2011-2012 Explorer  
2011-2013 Edge

2011-2013 MKX

This article supersedes TSB **12-3-3** to update the Issue Statement, Service Procedure and Part List.

**ISSUE**

Figure 1 - Article 12-10-7

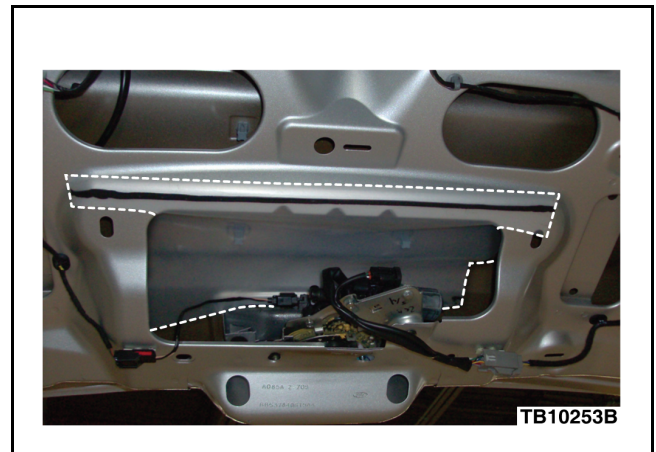
1. Determine vehicle and vehicle build date.
  - a. 2012-2013 Edge/MKX built on or before 3/2/2012 or 2011-2012 Explorer, proceed to Step 2.
  - b. 2011 Edge/MKX, proceed to Step 3.
2. Reprogram the liftgate/trunk module (LTM) to the latest calibration using IDS release 81.02 or higher. This new calibration is not included in the IDS 2012.9 DVD. Calibration files may also be obtained at [www.motorcraft.com](http://www.motorcraft.com). Proceed to Step 4.
3. Replace liftgate/trunk module (LTM). Refer to Workshop Manual (WSM), Section 501-03.
4. Remove liftgate trim panel. Refer to WSM, Section 501-05.
5. Install water deflector. Ensure it is tucked over liftgate latch and liftgate release switch. (Figure 1)

Figure 2 - Article 12-10-7

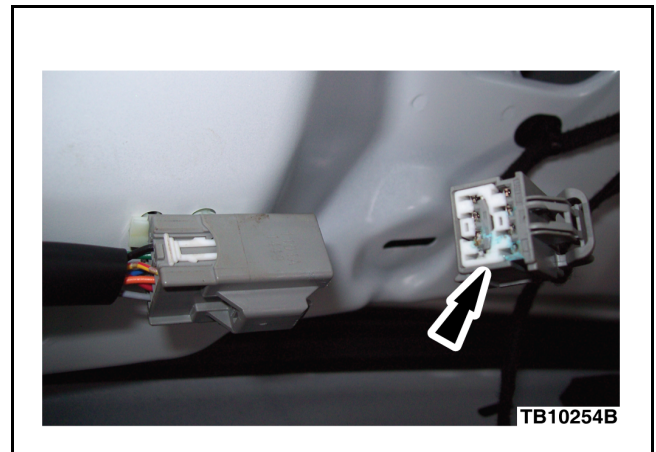
6. Disconnect connectors C4216, C432 and C4339. Refer to Wiring Manual, Section 109-1.
7. Inspect each connector for evidence of water intrusion and/or corrosion. Is evidence of water or corrosion present? (Figure 2)

- a. No - Proceed to Step 8.
- b. Yes - Proceed to Step 9.
